Re: Response to Regional Board Letter on Proposed Orders Related to Valley Water's McKittrick Facility

DOCUMENT REVIEW, MONITORING WELL INSTALLATION AND SAMPLING PLAN, MCKITTRICK 1 & 1-3 FACILITY, KERN COUNTY

SUBJECT: DOCUMENT REVIEW, MONITORING WELL INSTALLATION AND SAMPLING PLAN, MCKITTRICK 1 & 1-3 FACILITY, KERN COUNTY

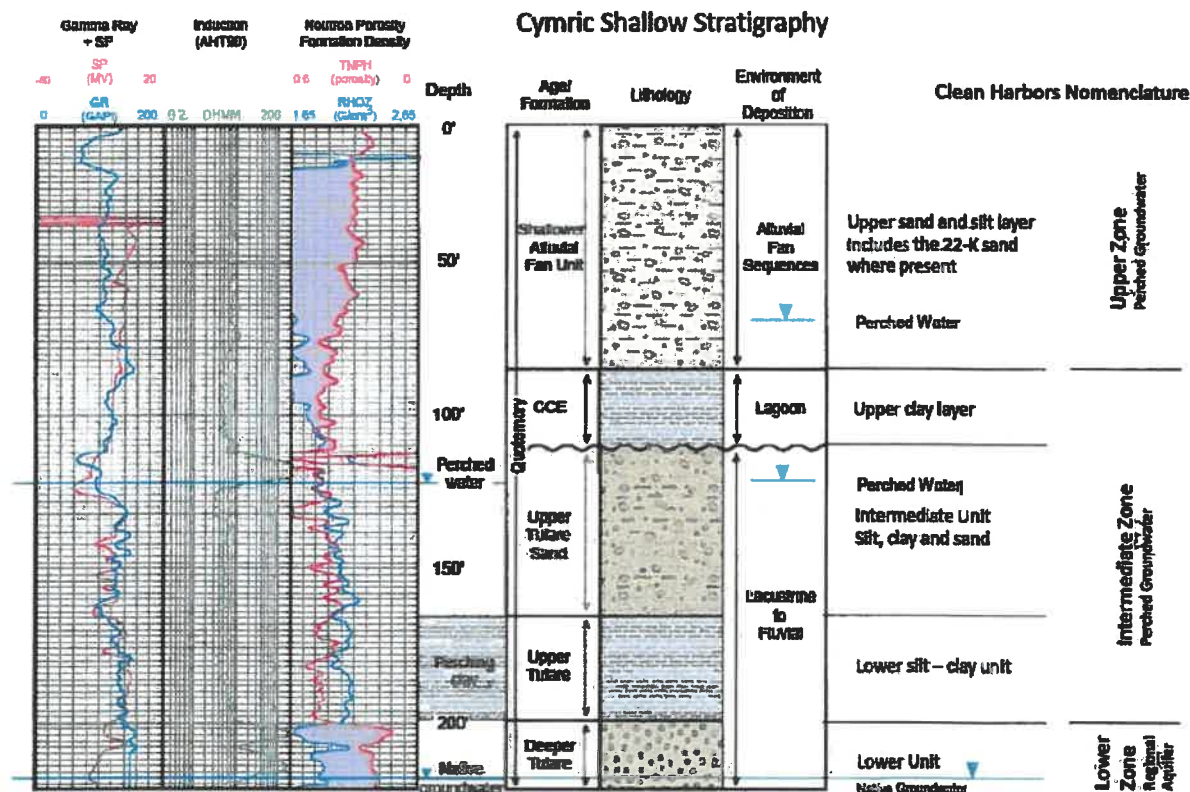
1. **Stratigraphy:** The Upper Alluvium unit beneath McKittrick does not have perched water above the Corcoran Clay Equivalent (CCE), while the stratigraphically-equivalent Upper Zone beneath Clean Harbors does have perched water. Question 1: How can produced water migrate vertically upwards from below the CCE and flow upwards through the CCE to be found in the "Upper Perched Zone" at Clean Harbors?

2. **Chemistry:** The water chemistry shows high levels of constituents, such as nitrate, that are not present in McKittrick's produced water. Question 2: How can a fairly high concentration of nitrate showing up downgradient beneath Clean Harbors, when nitrate is not found at detectable levels in the produced water, and not found beneath the McKittrick facility or in the groundwater monitoring wells at significant concentrations?

3. **Other sources.** Extensively irrigated land sits adjacent to the one location on Clean Harbors' property that has perched groundwater in both the Upper Perched Zone and the Intermediate Perched Zone. Question 3: How can irrigated agriculture not be explored as the cause and effect of the water under Clean Harbors given issues 1 and 2 above?

Attached below is a stratigraphic section, developed collaboratively between Valley Water and Regional Board staff, which shows how the stratigraphy beneath the McKittrick facility correlates to the stratigraphy beneath Clean Harbors. Beneath the McKittrick ponds, the Upper Alluvium does not have perched water as the CCE is predominantly silty and, therefore, does not significantly restrict the downward migration of produced water. In contrast, beneath the northwest portion of the Clean Harbors facility, the CCE is more clay-rich and *does* act as a relatively impermeable barrier allowing water to perch beneath the Clean Harbors facility. The Upper Perched Zone under the northwest portion of the Clean Harbors facility is saturated while the Upper Alluvium beneath the McKittrick facility is not saturated.

The source of recharge to the Upper Perched Zone under the northwest portion of the Clean Harbors facility appears to be adjacent agricultural infiltration. No known physical mechanism exists whereby water from McKittrick, which first occurs *beneath* the CCE, could travel downgradient to Clean Harbors, and then migrate upwards *through* the CCE. The water found in the Upper Perched Zone beneath Clean Harbors cannot be from the McKittrick facility (as described above), but does contain nitrate compounds that implicate irrigated water as the potential source of the perched water beneath the Clean Harbors Facility. The fact is, perched water at Clean Harbors is most notably associated with relatively high concentrations of nitrate compounds, and relatively low concentrations of boron; neither of which are typical of produced water, but both are characteristic of percolation from irrigated fields. Taken together, the geochemistry indicates that the limited area of perched water at Clean

The water found in the Intermediate Perched Zone beneath Clean Harbors resembles that of the Upper Perched Zone and, therefore, is most likely to be Upper Perched Zone water that has slowly seeped through the CCE to perch above the Upper Tulare perching clay/lower silt-clay unit.
